Board of Zoning Adjustment
Staff Report
August 7, 2017

Case No:	17CUP1032
Project Name:	Willis-Klein Off-Street Parking Expansion
Location:	284 Ridgeway Avenue
Owner(s):	M.J. Klein, LLC
Applicant:	M.J. Klein, LLC
Jurisdiction:	St. Matthews
Council District:	9– Bill Hollander
Case Manager:	Jon Crumbie, Planning & Design Coordinator

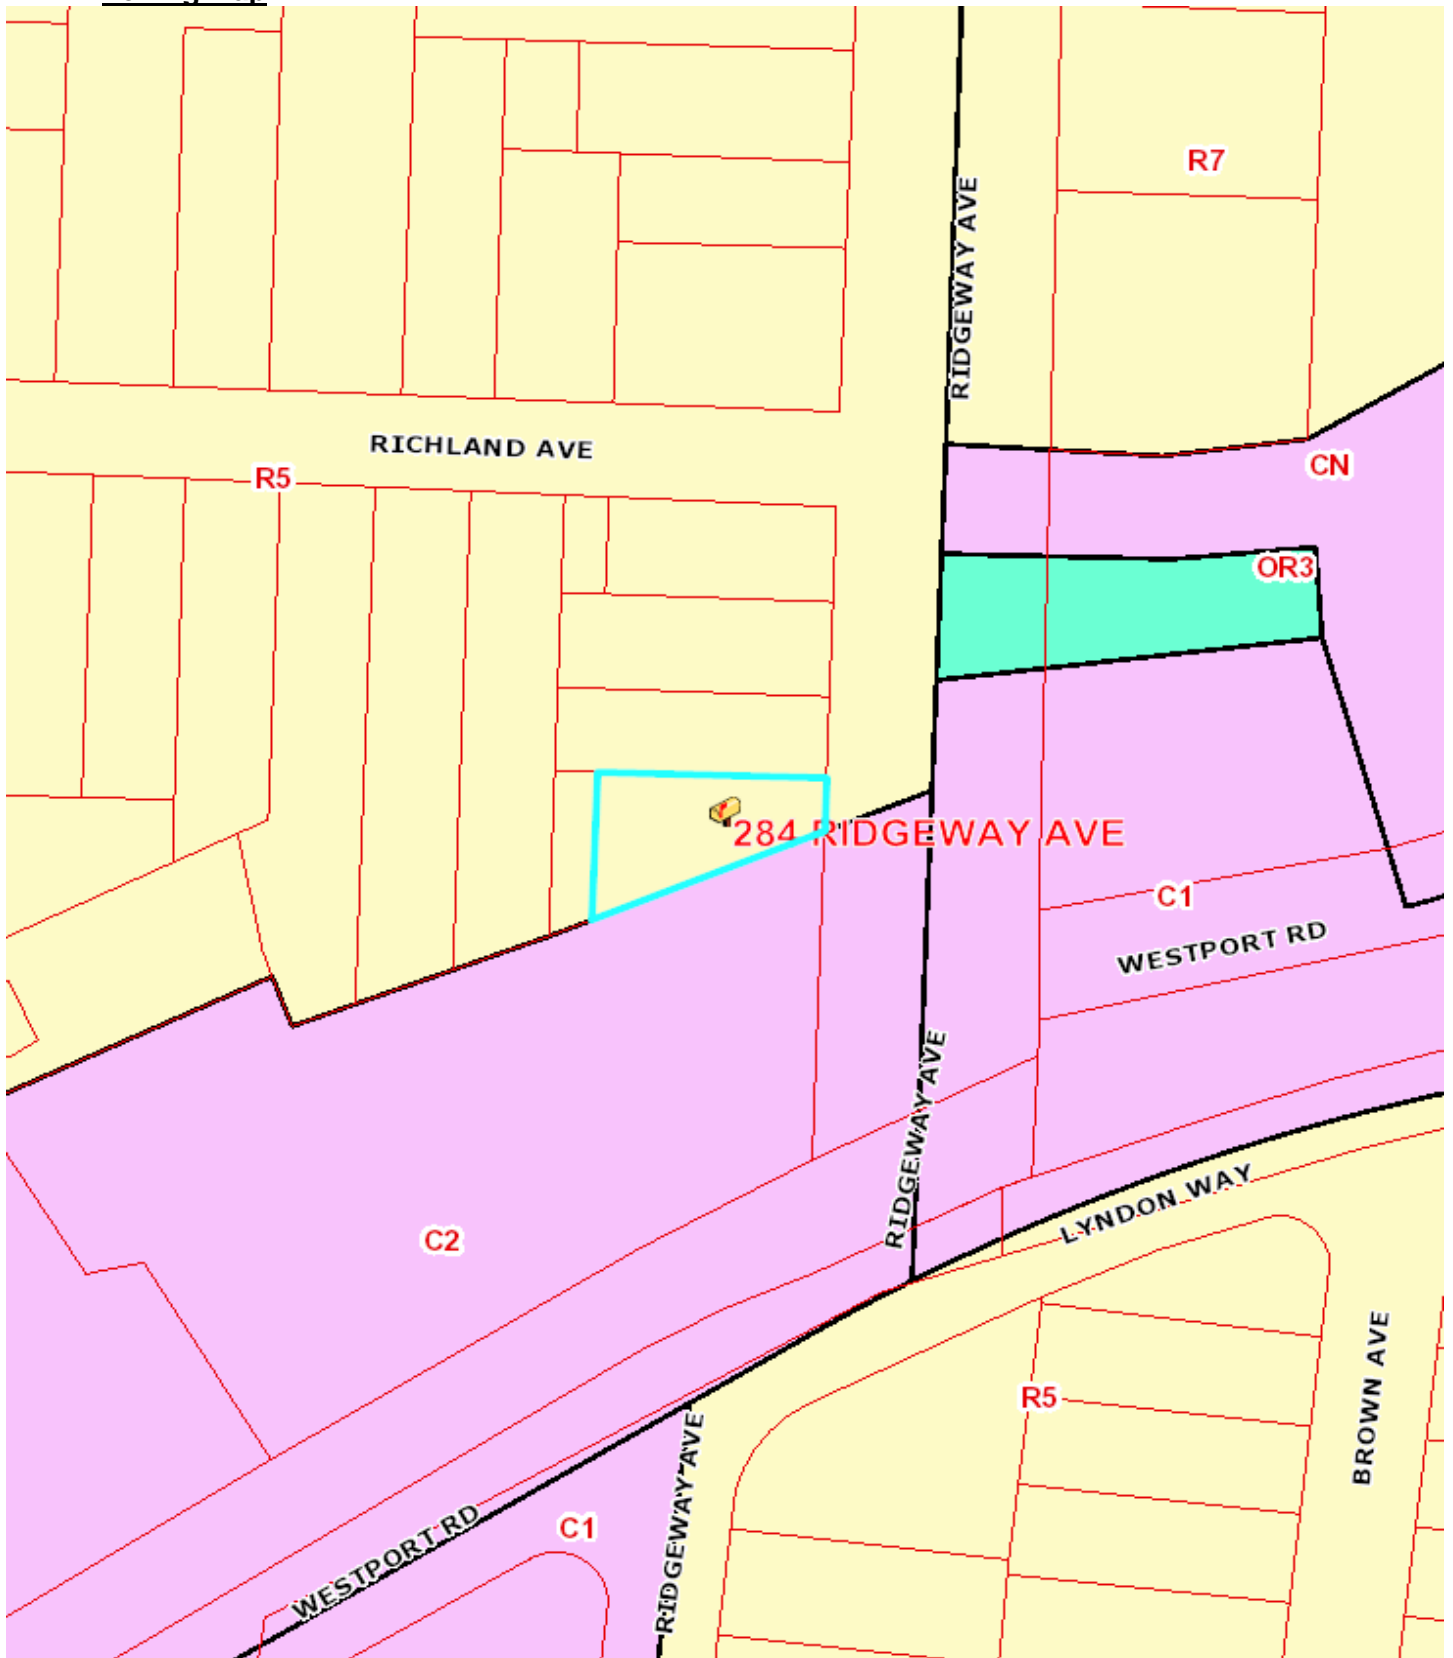
c. The minimum front, street side, and side yards required in the district shall be maintained free of parking. **The required front yard along Ridgeway Avenue is 25 feet. The parking/maneuvering area will be 12.50 feet from the front property line. The required side yard along the south property line is 5 feet. The parking/maneuvering area will be located on the property line.**
